AMENDMENT OF SOLICITATION/MODIFICATION OF CONTRACT			1. CONTRACT ID CODE J	PAGE OF PAGES 1   8
2. AMENDMENT/MODIFICATION NO. 0008	3. EFFECTIVE DATE 19-Apr-2004	4. REQUISITION/PURCHASE REQ. NO. W16ROE-3363-4250	5. PROJECT NO.(If applicable)

14. DESCRIPTION OF AMENDMENT/MODIFICATION (Organized by UCF section headings, including solicitation/contract subject matter where feasible.) The purpose of this amendment is to revise site location and size of buildings and to notify offerors of the following changes :  The Revised Final Price proposals are due on 27 April 2004 by 2:00 pm to the same location and person as the original proposals. Please provide six copies of Volume II. No changes to tech proposals will be accepted. Subcontracting proposals are not required.  All other terms and conditions remain the same.  NOTE: Bidders must acknowledge receipt of this amendment by the date specified in the solicitation (or as amended) by one of the following methods: in the space provided on the SF1442, by separate letter, by telegram, or by signing block 15 below. FAILURE TO ACKNOWLEDGE AMENDMENTS BY THE DATE AND TIME SPECIFIED MAY RESULT IN REJECTION OF YOUR BID IN ACCORDANCE WITH THE LATE B

SHEET REFERENCE NUMBER:  
**A-1a**

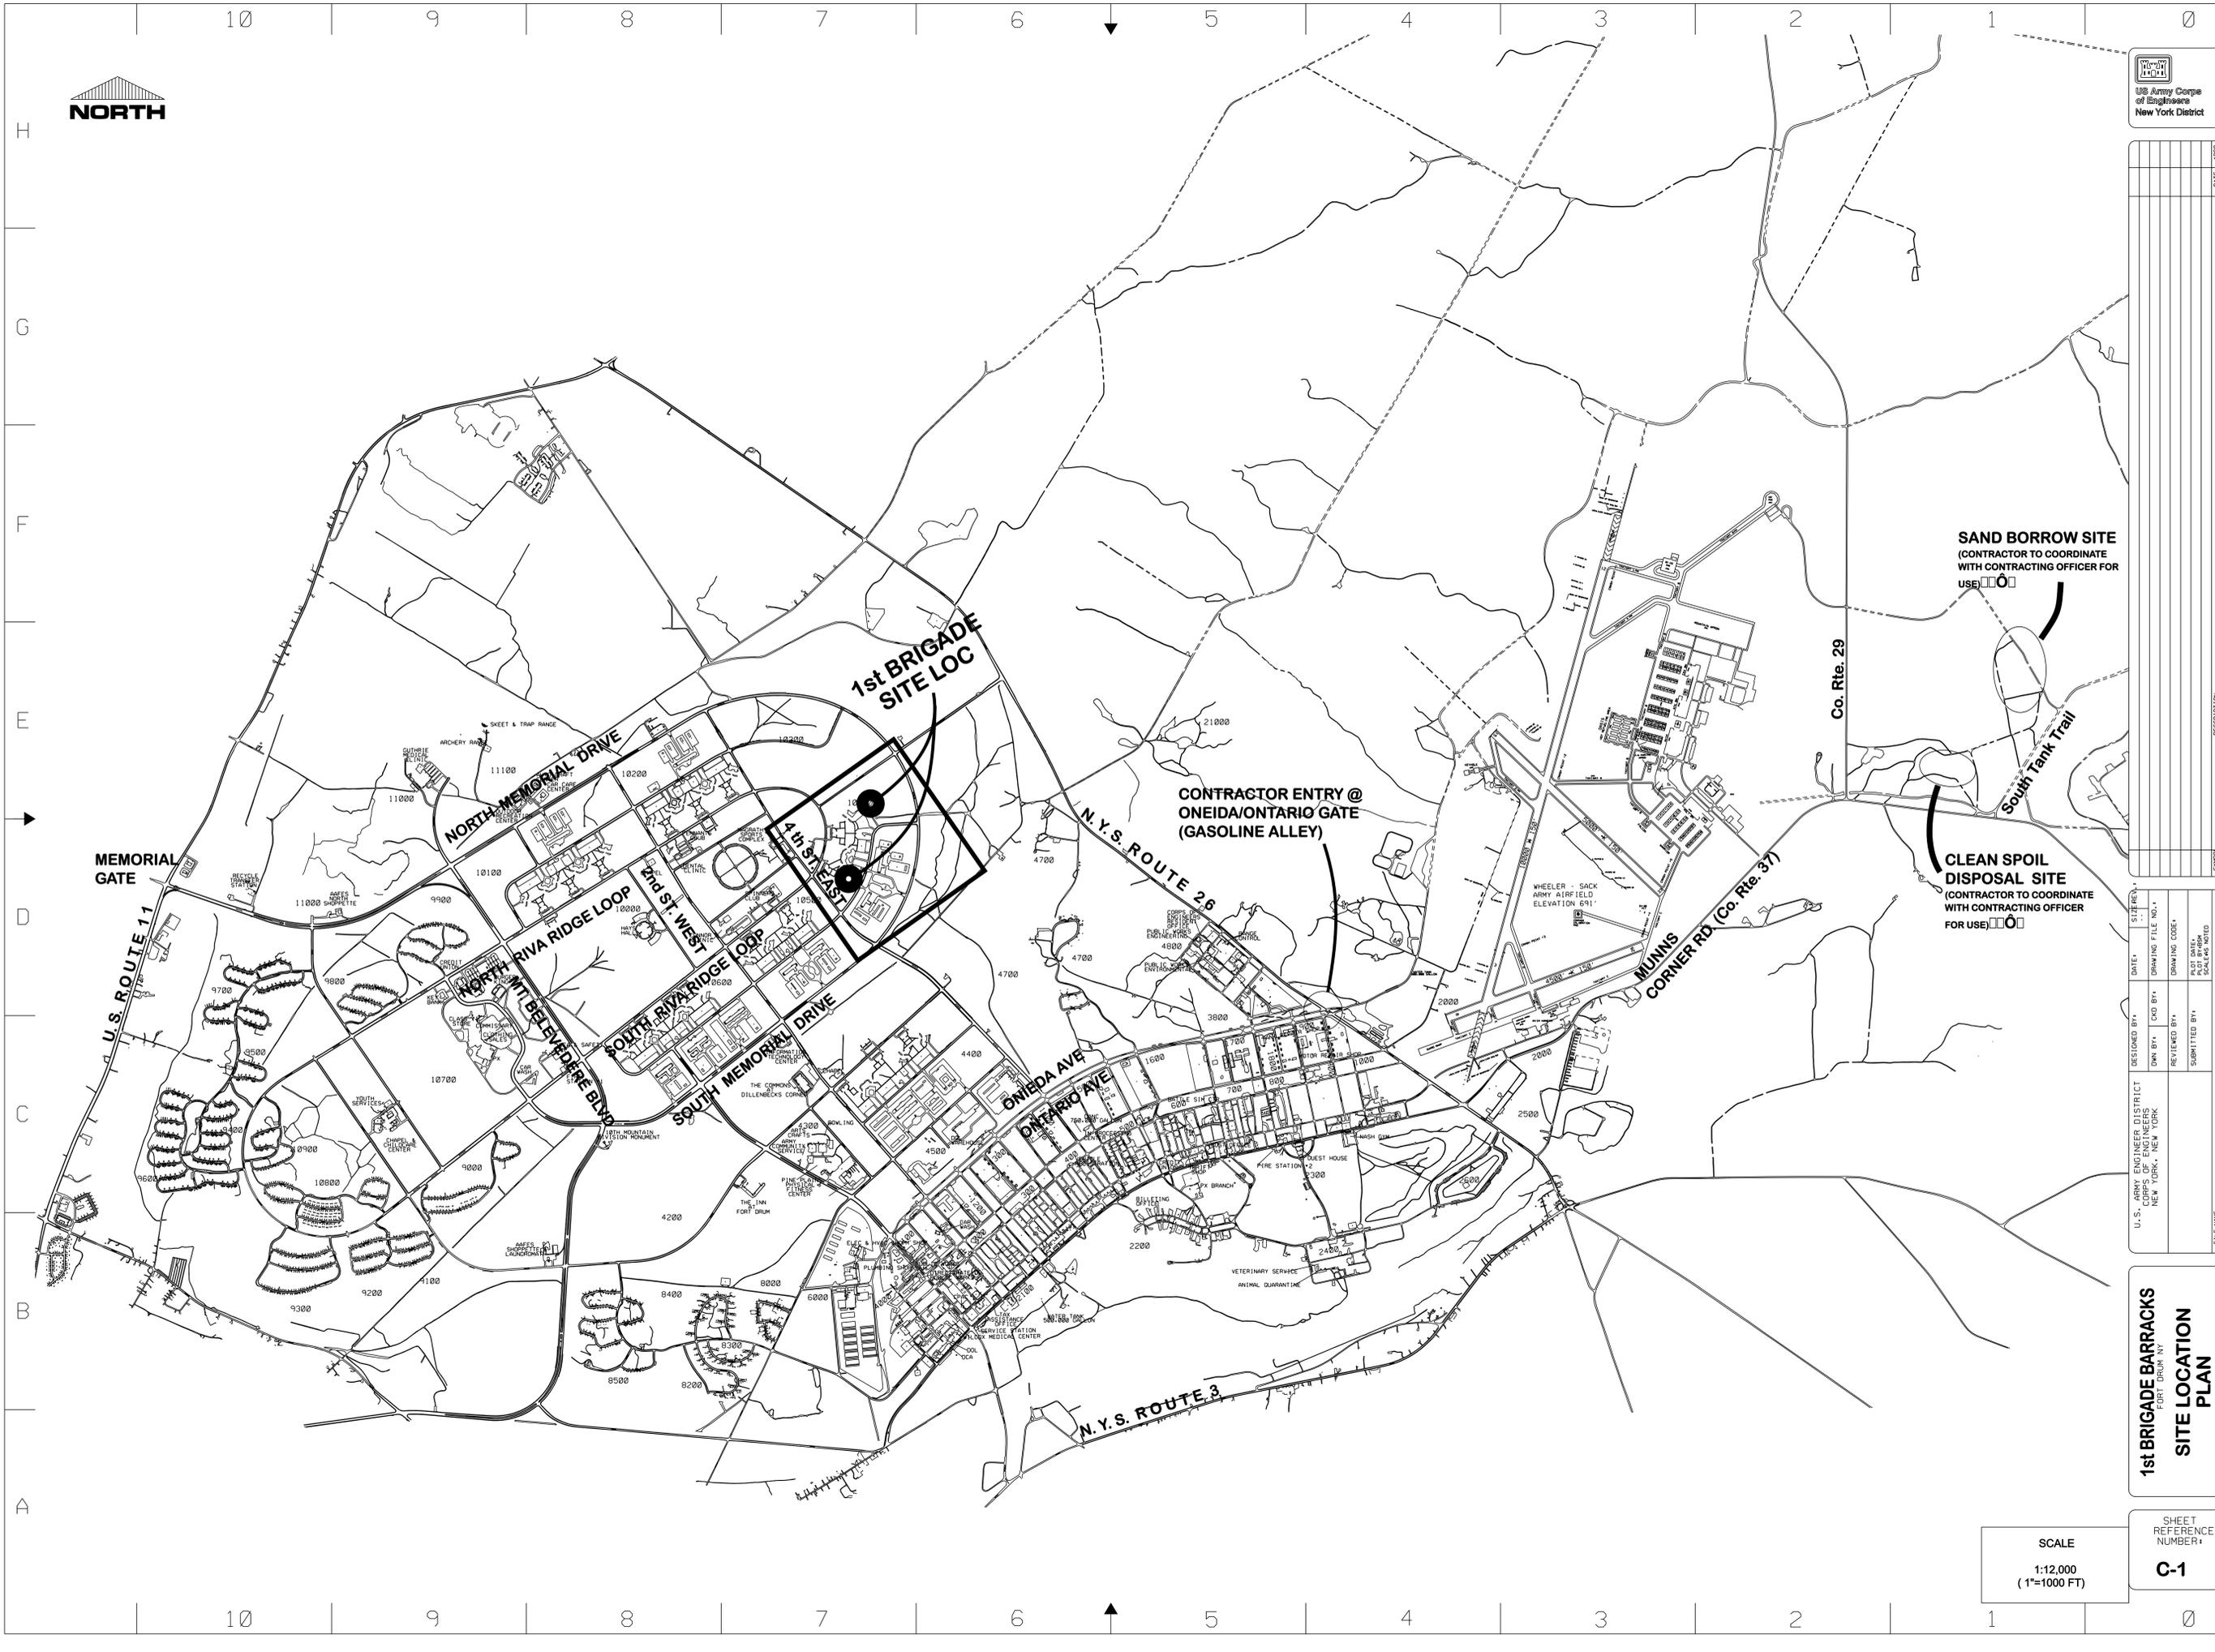
**Section 01010, paragraph 1.1** Delete fourth fifth and sixth sentence; Replace with “The project consists of three buildings, two of which are a 104-man, two-story facility of approximately 3,455 sq. m. and one of which is a 64-man, two story facility of approximately 2,249 sq. m. (gross floor area as calculated per TI 800-01 and as elaborated on drawing A-1) designed to provide new Unaccompanied Enlisted Personnel Housing with quarters for a total of 276

**Sheets A-1 & A-2** Shall be deleted. Replace with sheets A-1a, A-1b, A-2a & A-2b.
